# Access Compliance Report

## Public Rights-of-Way

### (Curb Ramps)

Intersection ID: 3180	Main Street: JOHNSTON_OEHLER_RD	Cross Street: SONG_SPARROW_LN	Location:	N
ADA ID: 8D14883A5B1E	Ramp Type: PerpDiag	Initial Pass/Fail: Fail	Overall Compliance: No	Severity Score: 25
Codes/Mitigation Info/Possible Solution		Field Measurements/Component Compliance

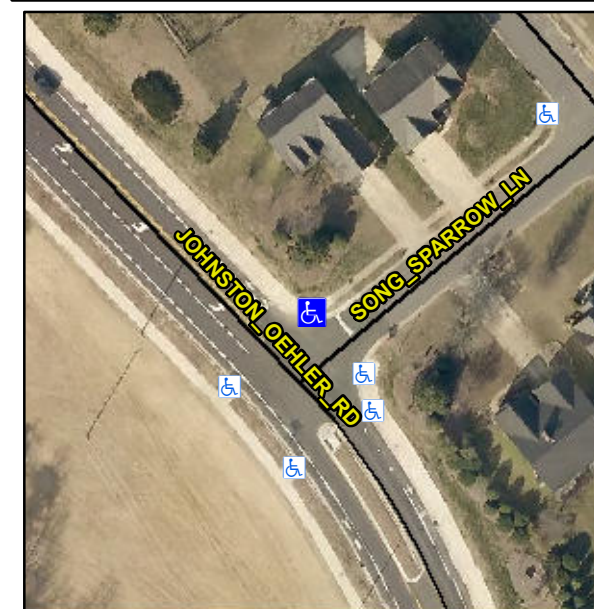
Compliance	Description	Data	Compliance	Description	Data
N/A	Ramp Length (in)	12.0	No	Ramp Slope (%)	12.6
Yes	Ramp Width (in)	48.0	Yes	Ramp XSlope (%)	0.7
N/A	Flare Type LT	N/A	N/A	Flare Type RT	N/A
N/A	Flare Slope LT (%)	N/A	N/A	Flare Slope RT (%)	N/A
N/A	Flare Traversable LT?	N/A	N/A	Flare Traversable RT?	N/A
N/A	Landing Length (in)	N/A	N/A	DWS Provided?	N/A
N/A	Landing Width (in)	N/A	N/A	DWS Contrast?	N/A
N/A	Landing Slope (%)	N/A	N/A	DWS Length (in)	N/A
N/A	Landing X Slope (%)	N/A	N/A	DWS Full Width?	N/A
N/A	Landing Curb? (Y/N)	N/A	N/A	DWS Offset (in)	N/A
N/A	Shared Landing?	N/A			
N/A	Gutter Ponding?	N/A	N/A	Gutter Slope (%)	N/A
N/A	Gutter Lip Ht (in)	N/A	N/A	Gutter X Slope (%)	N/A
N/A	Painted X Walk1?	No	N/A	Painted X Walk2?	No
	X Walk 1 Direction	To SW		X Walk 2 Direction	To SE
N/A	X Walk 1 Width (in)	N/A	N/A	X Walk 2 Width (in)	N/A
	X Walk 1 Slope (%)	0.3		X Walk 2 Slope (%)	0.6
	X Walk 1 X Slope (%)	0.5		X Walk 2 X Slope (%)	1.2

**Remove & Replace Curb Ramp With Two New Directional Ramps or Equivalent.**

**R304.2.2**
